Subject: Kaman Instrumentation for Palo Verde

POST-IMPLEMENTATION REVIEW OF NOBLE GAS EFFLUENT MONITORS  
(NUREG-0737, ITEM II.F.1, ATTACHMENT 1)  
INSTALLED AT PALO VERDE NUCLEAR GENERATING STATION, UNIT NO. 1

Figure 5. KDGM-ER DETECTOR IN KSG-HRH SAMPLER,  
HIGH RANGE POSITION  
ENERGY DEPENDENCE CHARACTERISTIC

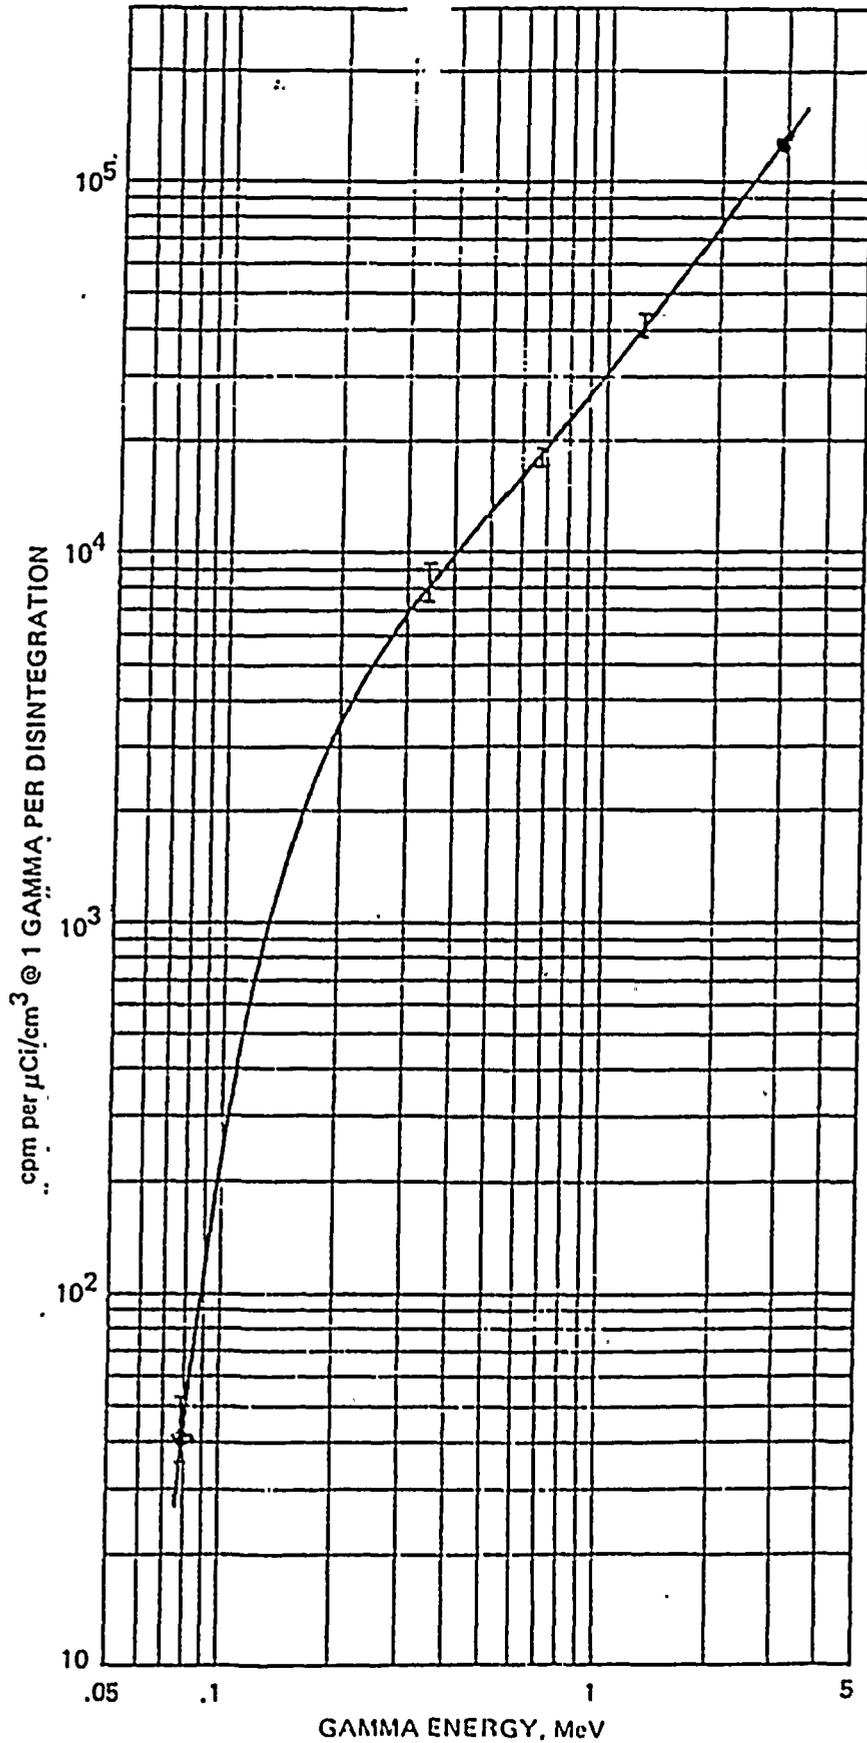
The staff obtained from the vendor the gamma energy response characteristic curves for the high range noble gas effluent monitor installed at Palo Verde, Unit No. 1 (Attachment 1), and that of the modified and proposed by the vendor (Attachment 2). The installed monitor energy response characteristics reveal an extreme energy dependency of approximately four decades (40 to  $1.3 \times 10^5$  cpm per uCi/cc) over the 80 Kev to 3 Mev gamma energy range. The fresh equilibrium noble gas fission product mixtures with higher energy gamma emissions would saturate the detector during the initial hours following an accident causing no indication on instrument readouts.

The maximum noble gas concentrations that the installed monitor could detect and measure without the possibility of monitor saturation at various photon

energy levels can be obtained by multiplying the ratios of two detector (installed and modified) efficiencies at a given photon energy with the maximum design noble gas concentration of  $10^5$  uCi/cc. For example, at a photon energy of 0.7 Mev per disintegration, the maximum noble gas concentration detectable and measurable is only 800 uCi/cc. Therefore, contrary to the statements in the FSAR, the monitors do not meet the requirements set out in NUREG-0737, Item II.F.1, Attachment 1 or range specification in Regulatory Guide 1.97, Revision 2. On the other hand, the modified detector described and proposed by the vendor (Attachment 2) has the energy response characteristics of a nearly linear 1.5 decade (35 to 650 cpm per uCi/cc) energy dependency over the same gamma energy range and meets the above requirements, and therefore would be acceptable.

Based on the foregoing evaluation, we find that the high range noble gas effluent monitors, as built and installed at Palo Verde, Unit No. 1, are not capable of detecting and measuring higher concentrations of all noble gas fission products in plant gaseous effluents during and following an accident, as specified in NUREG-0737, Item II.F.1, Attachment 1, and Regulatory Guide 1.97, Revision 2. Therefore, the monitors are not acceptable. Also, we find that the monitors with modified detector and sampler design by the vendor, as described and proposed in a letter to D. Gibson of Bechtel Power Corporation (Palo Verde Project) from D. Piraino
